TO: Bob Exstrom, Town of Parker
FROM: Stacey Nerger, Senior Planner
DATE: February 29, 2024
SUBJECT: Parker Town Hall Amendment 3 Lot 1 – Site Plan
Review Comments 02

Parker Town Hall Expansion

PARKER TOWN HALL EXEMPTION PLAN AMD3 L1 SITE PLAN SUBMITTAL

TREE CONSERVATION PLAN

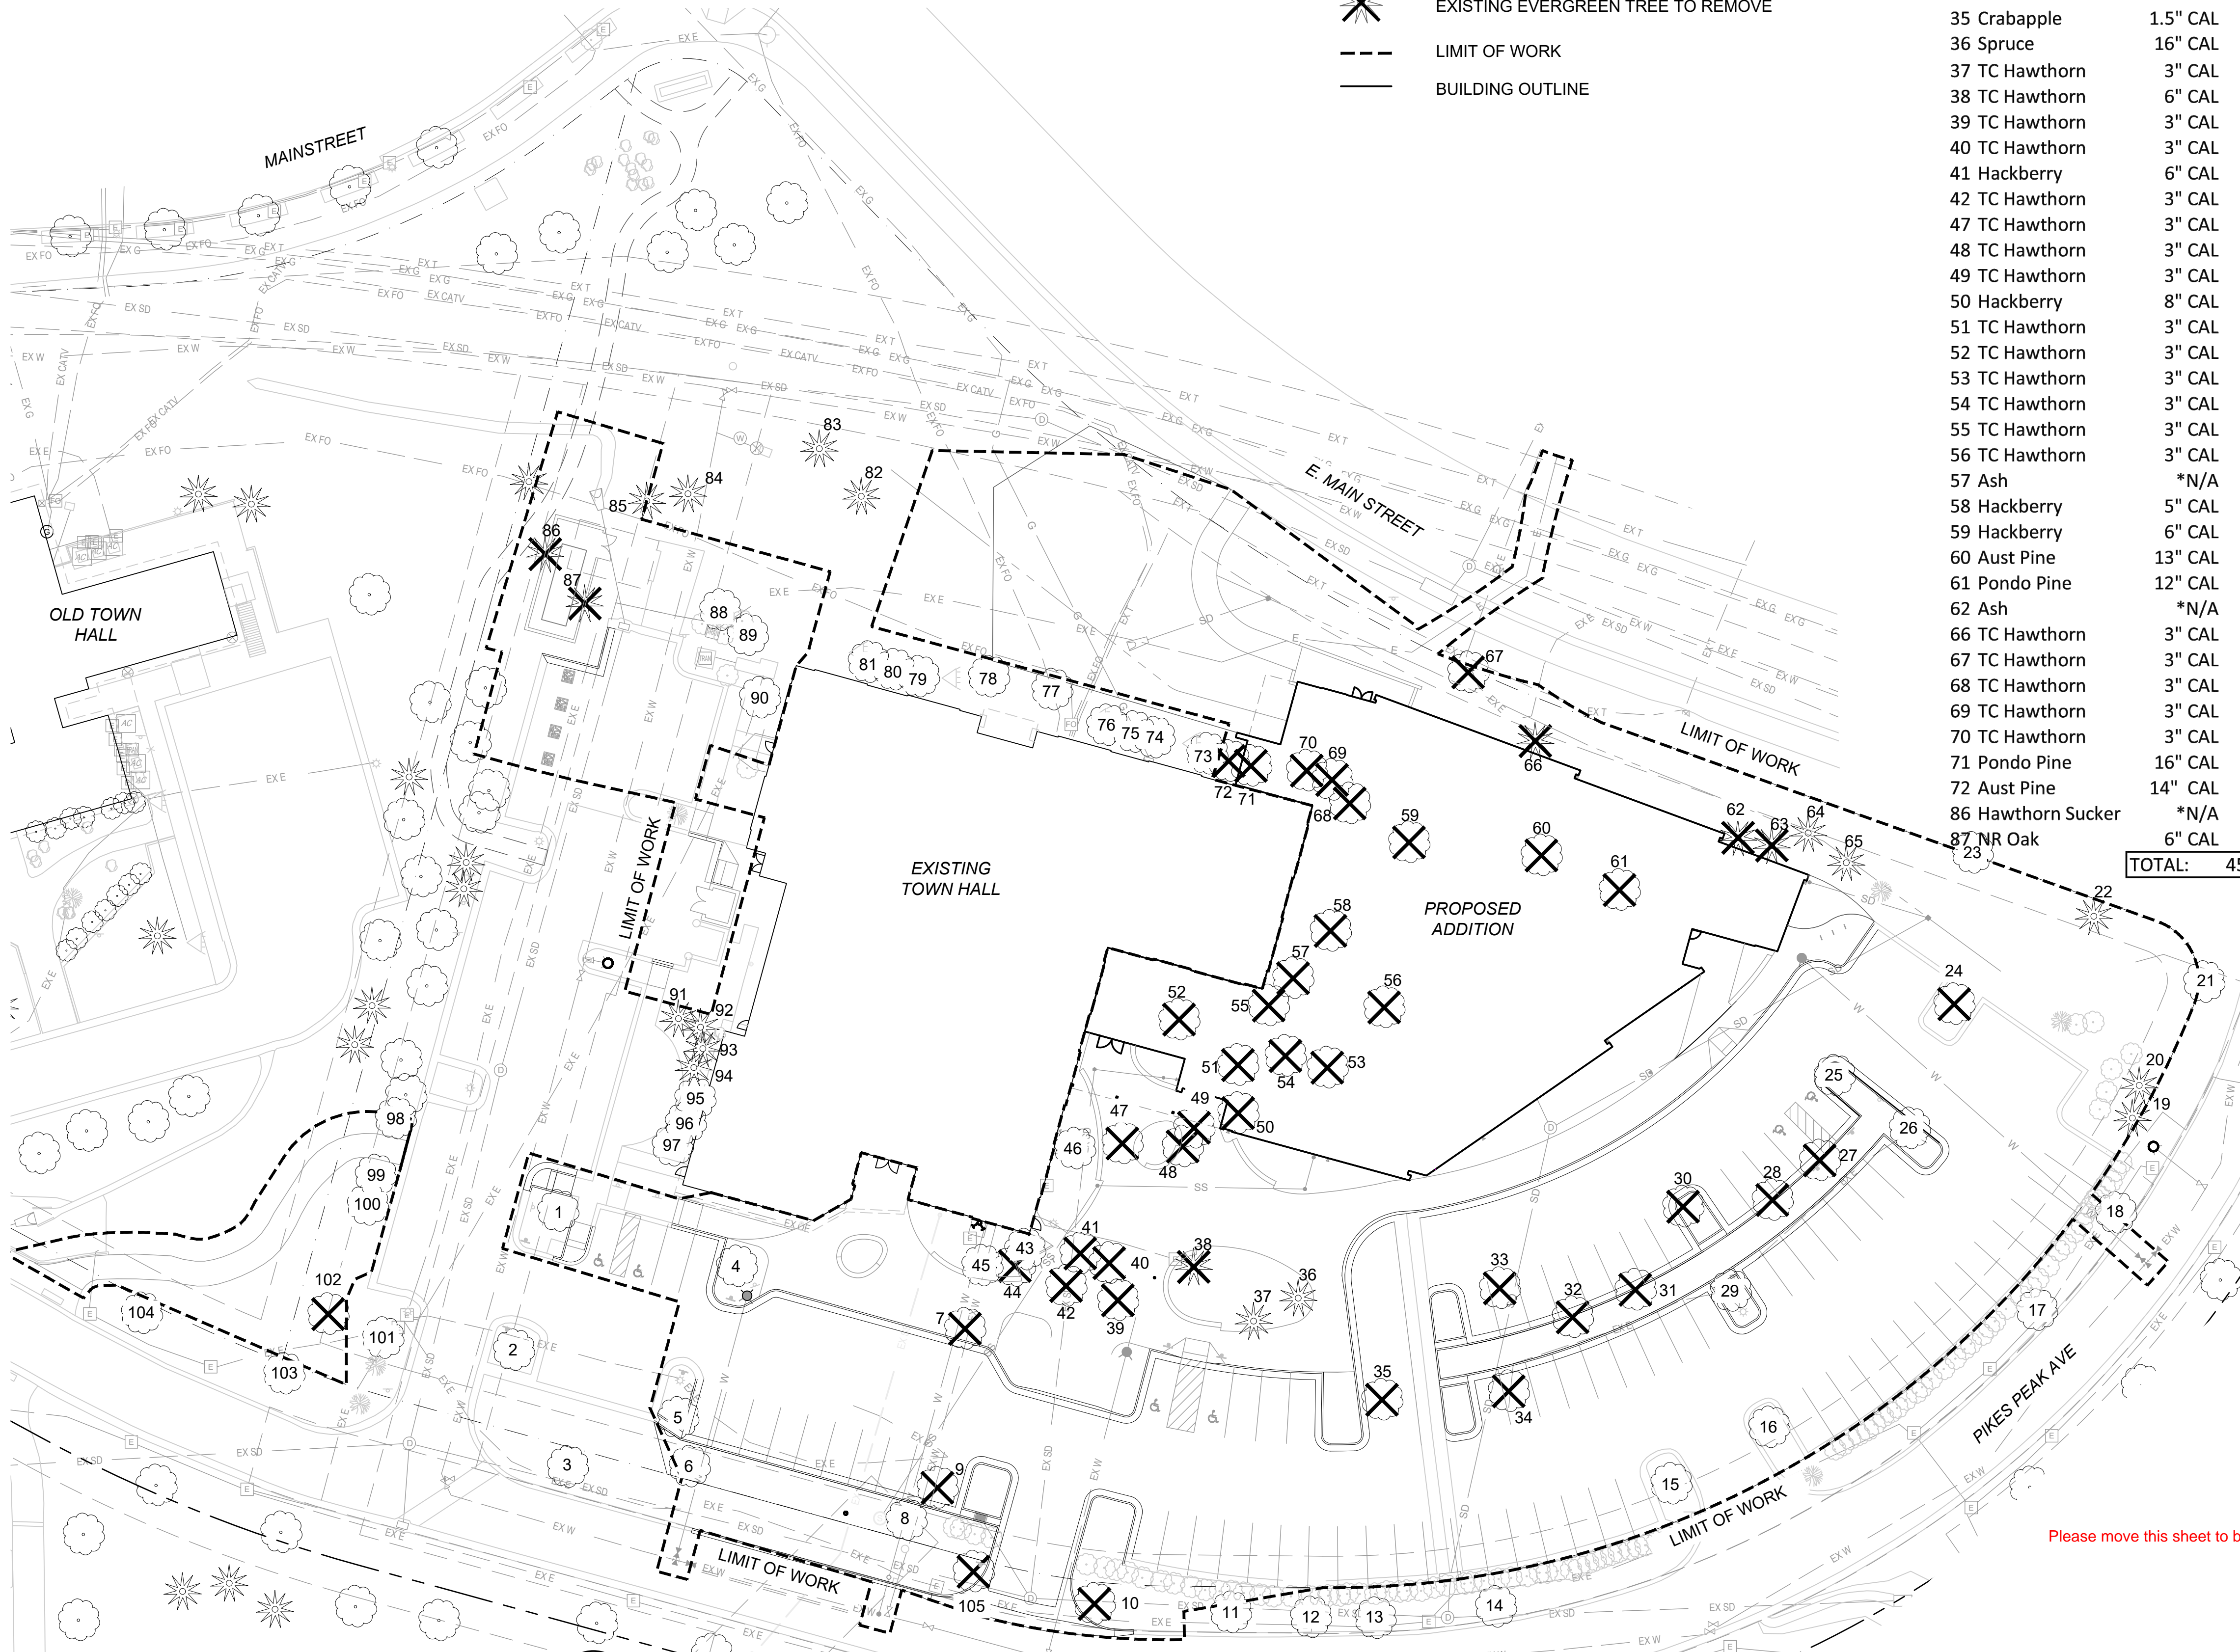
Is this correct?

This amount will either need to be paid to the Town or can be mitigated by adding additional trees (above what is required by code) to the Site Plan. If this will be paid, we need to work with Parks to determine how much money we have available to use.

Please move this sheet to be part of the landscape sheets.

EXTERIOR ELEVATION - NORTH

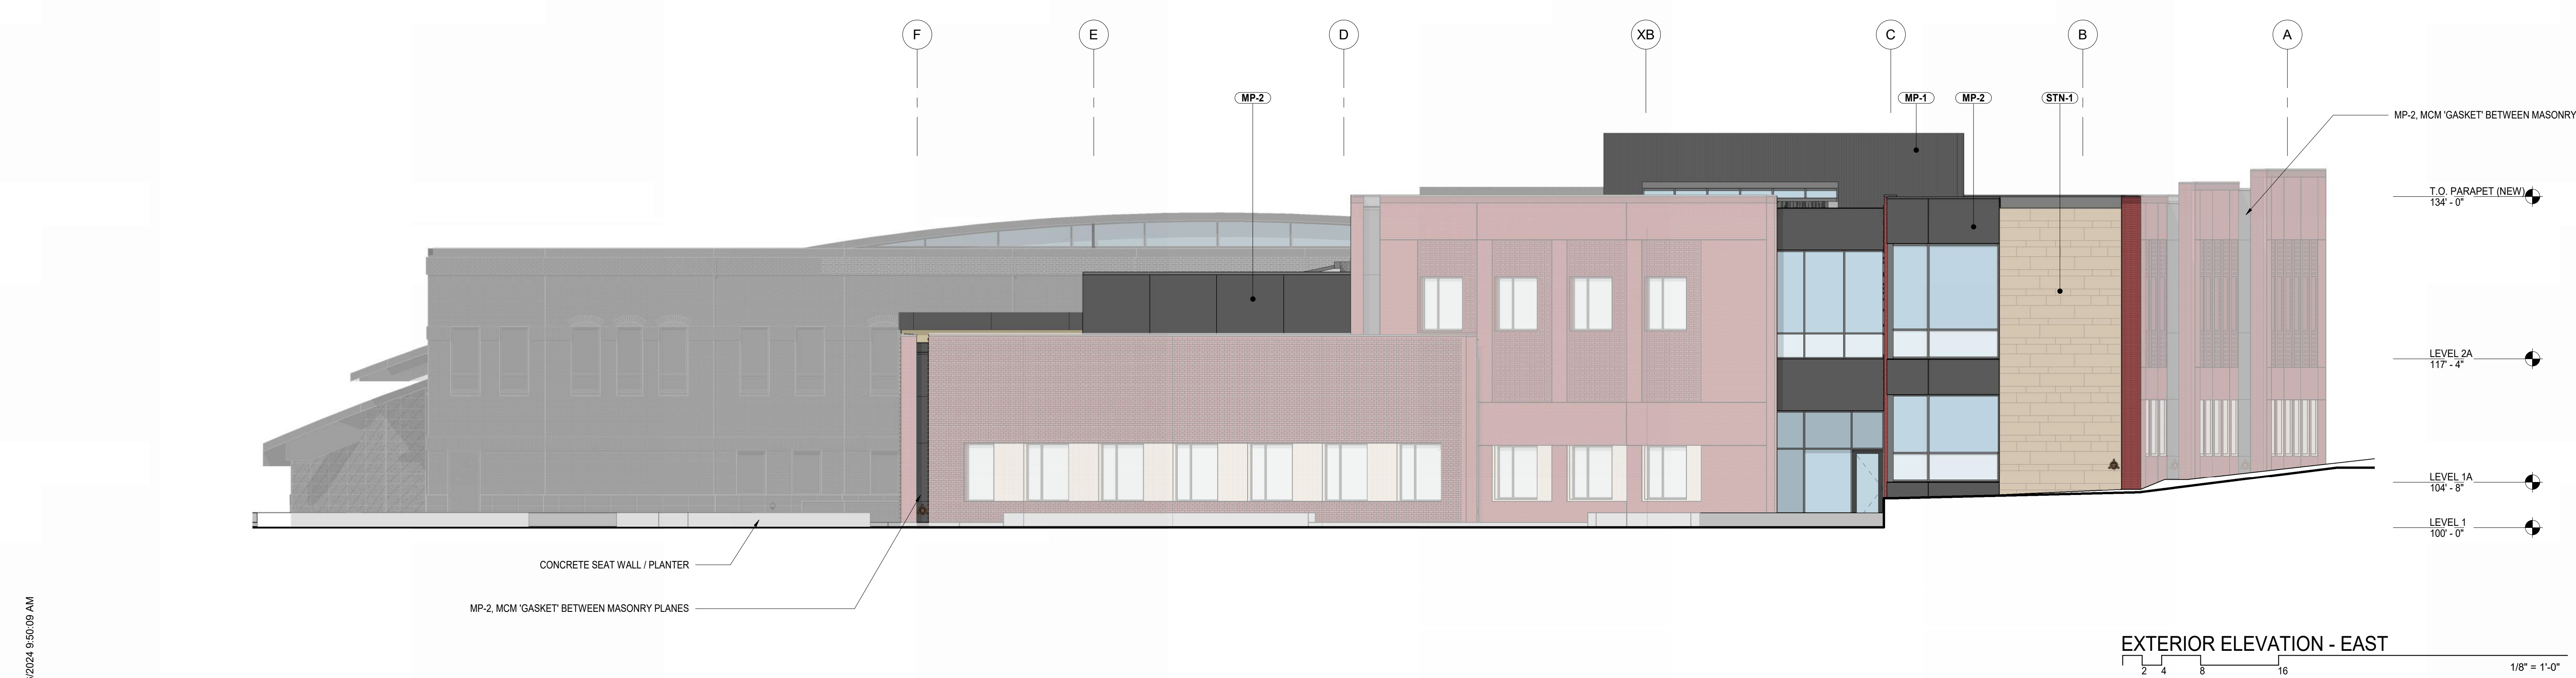
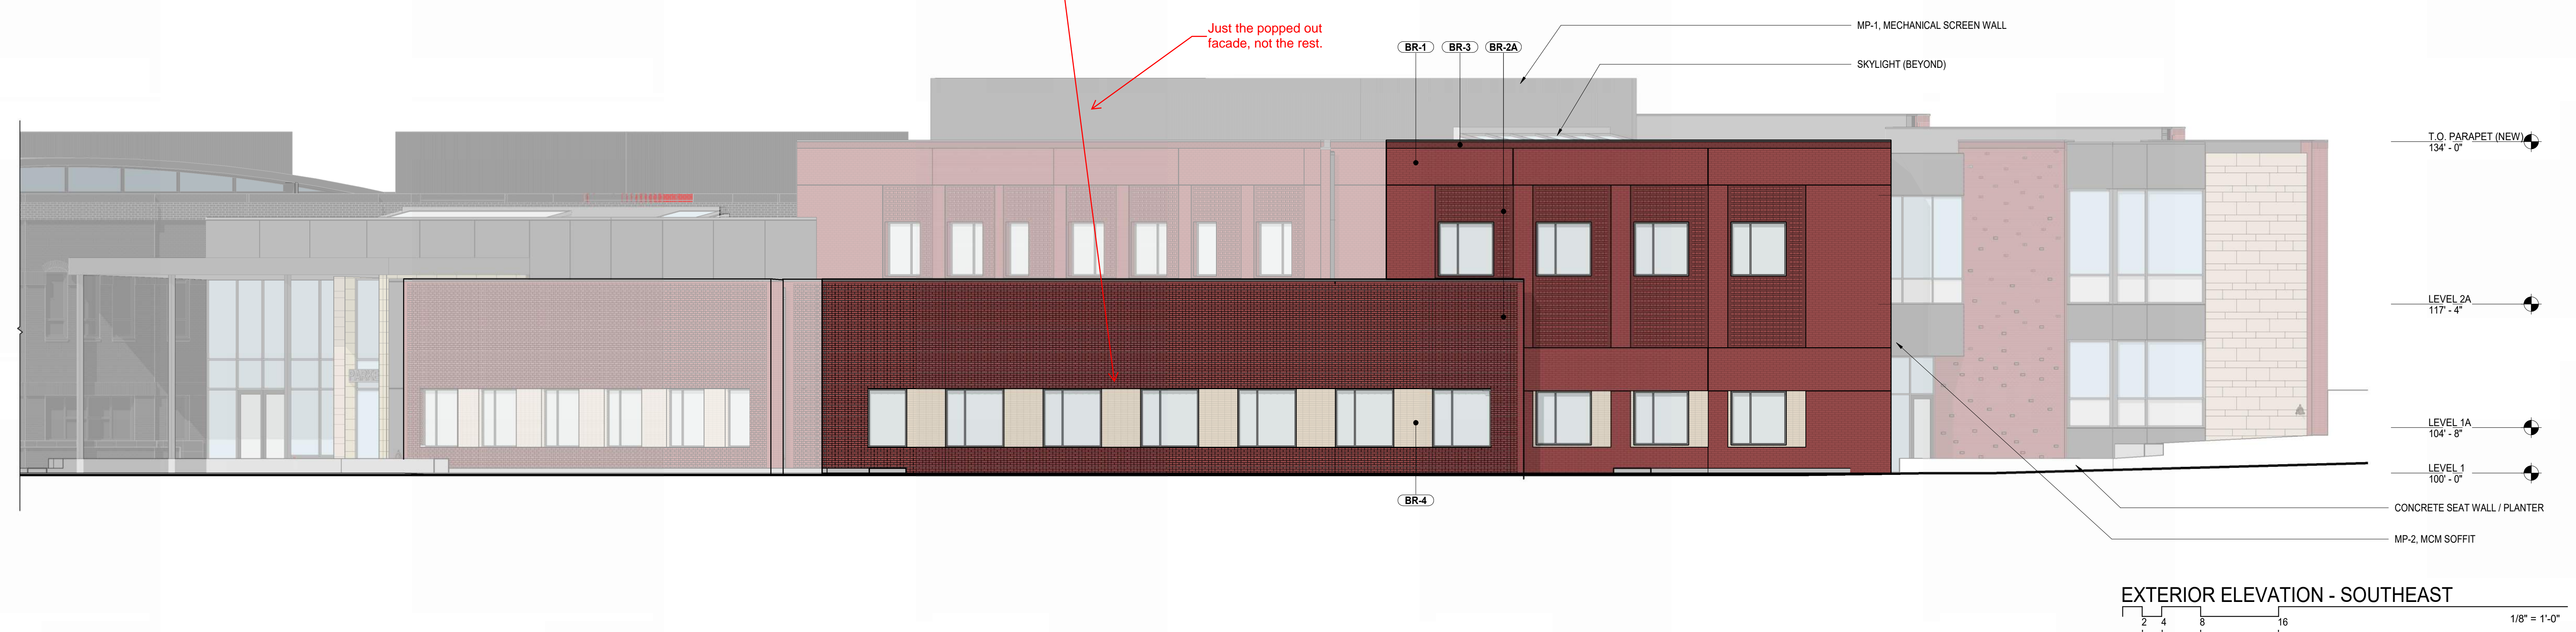
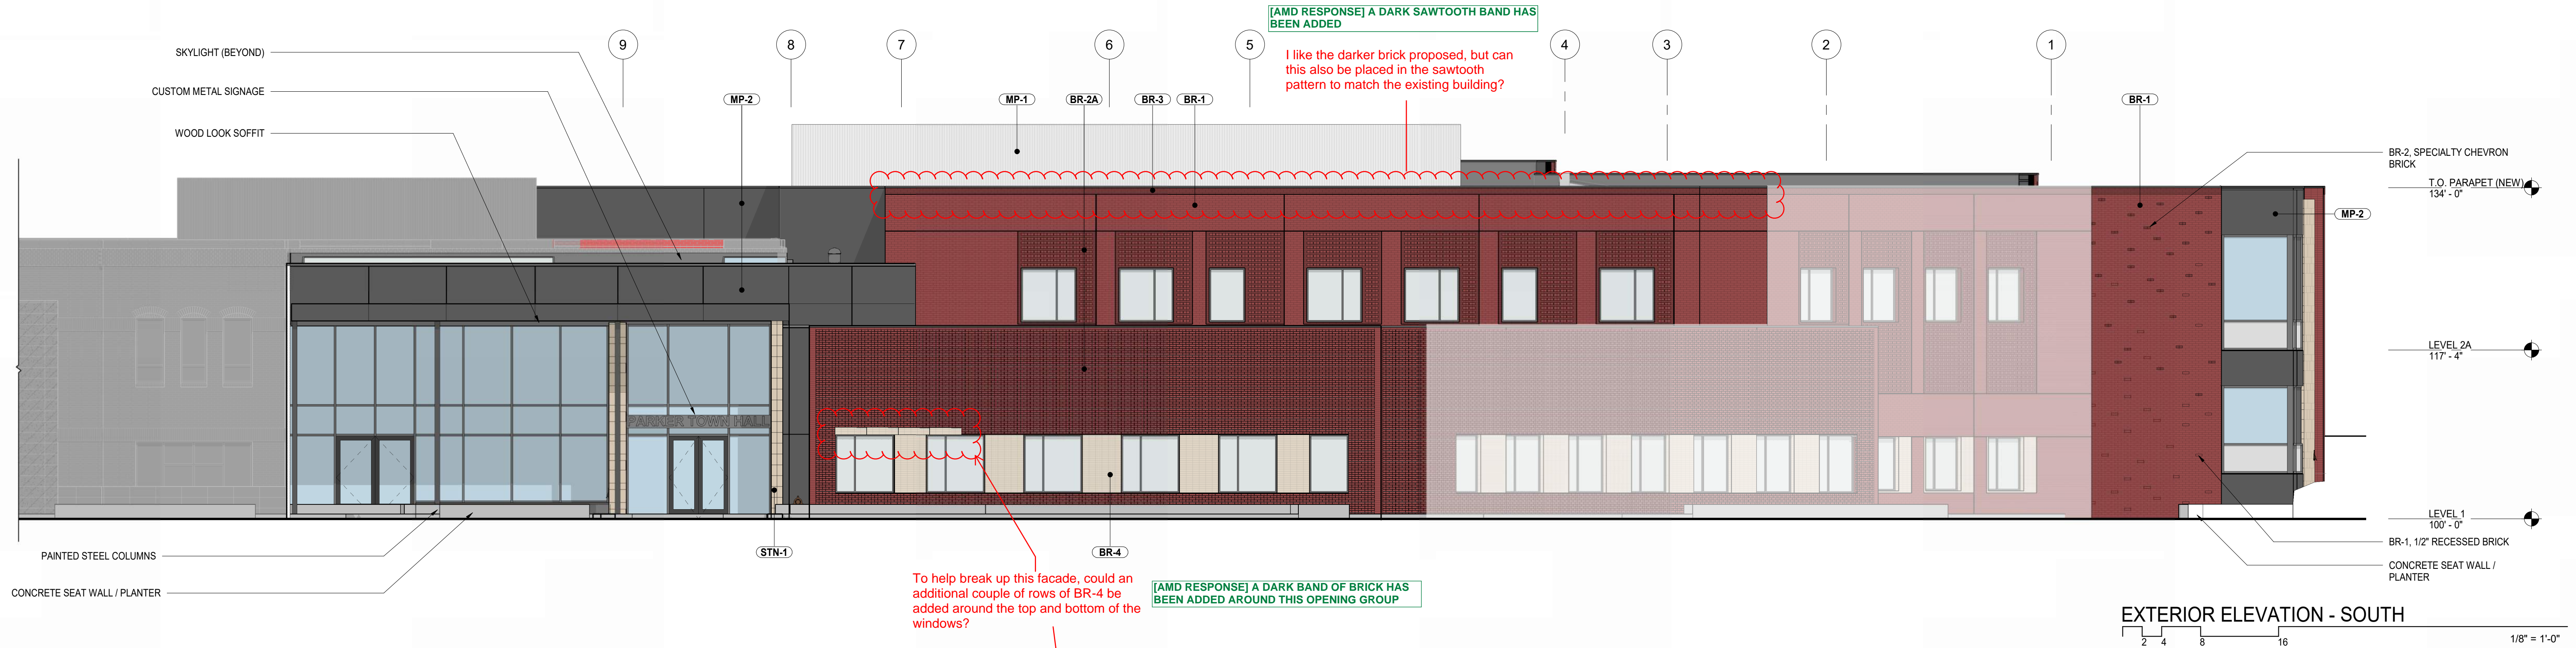
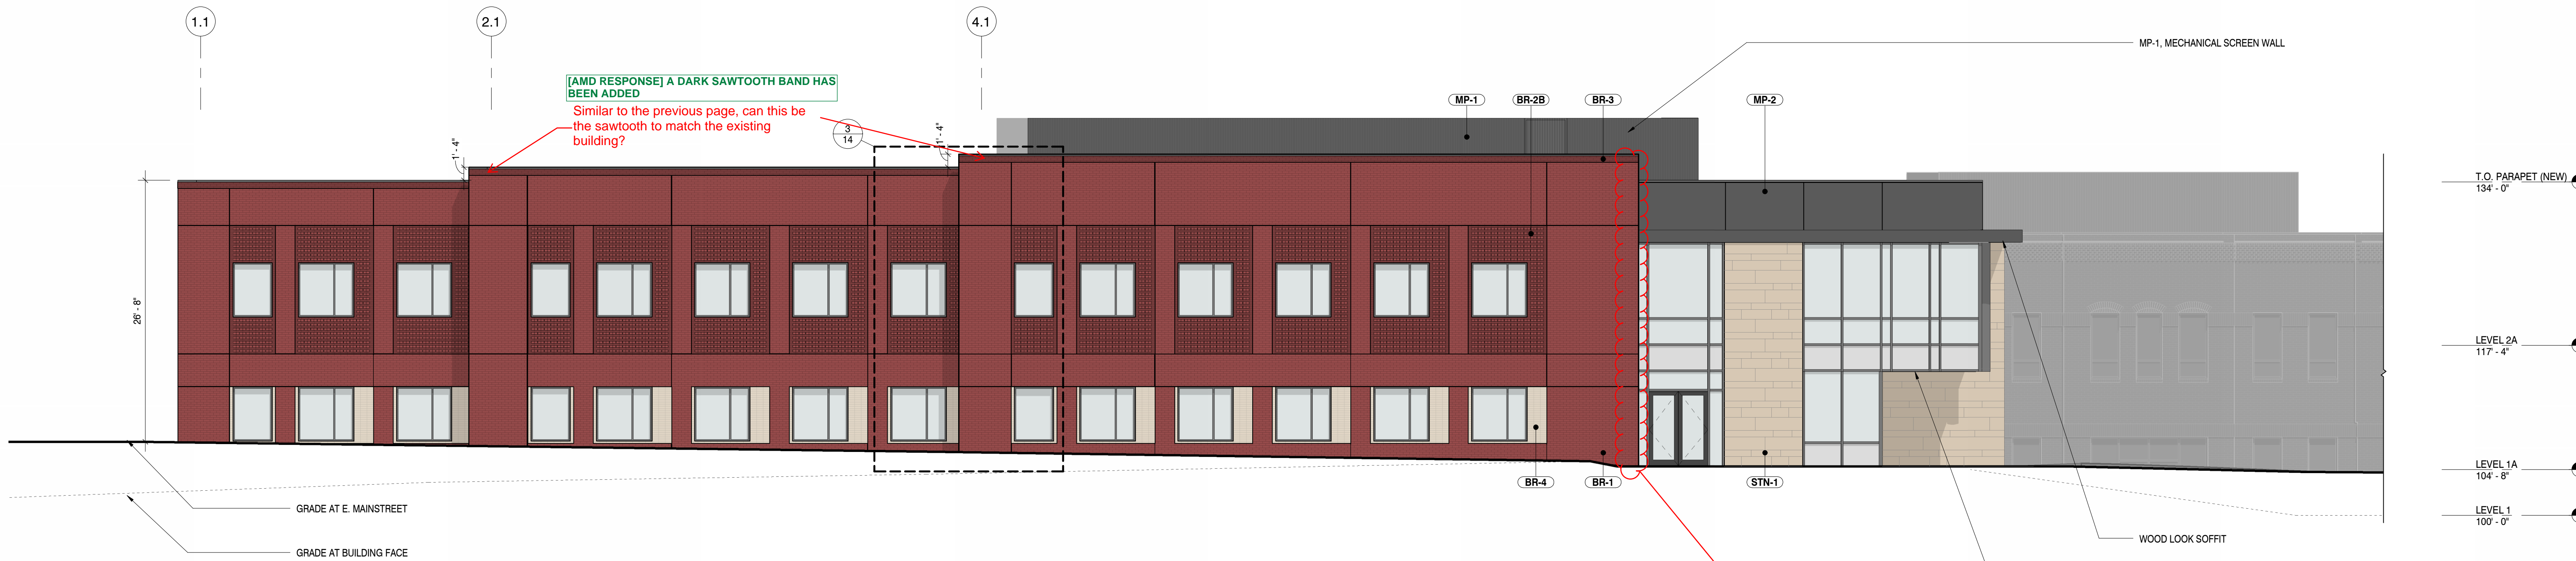
[AMD RESPONSE] A DARK SAWTOOTH BAND HAS BEEN ADDED. Similar to the previous page, can this be the sawtooth to match the existing building?

Along the edge of this, can you use BR-3 in the sawtooth to really frame this elevation? [AMD RESPONSE] SEE REVISED SHEETS TO CLARIFY END CONDITION

I know the note kind of explains this, but can you outline that these areas are BR-2B and BR-3 alternating? A blow up of how this work may be beneficial. [AMD RESPONSE] SEE REVISED SHEETS

If using the sawtooth as mentioned above can be done, it would also look really nice along this edge as well. [AMD RESPONSE] SEE REVISED SHEETS TO CLARIFY END CONDITION

Please add label for BR-1 to these facades for clarity. [AMD RESPONSE] SEE REVISED SHEETS
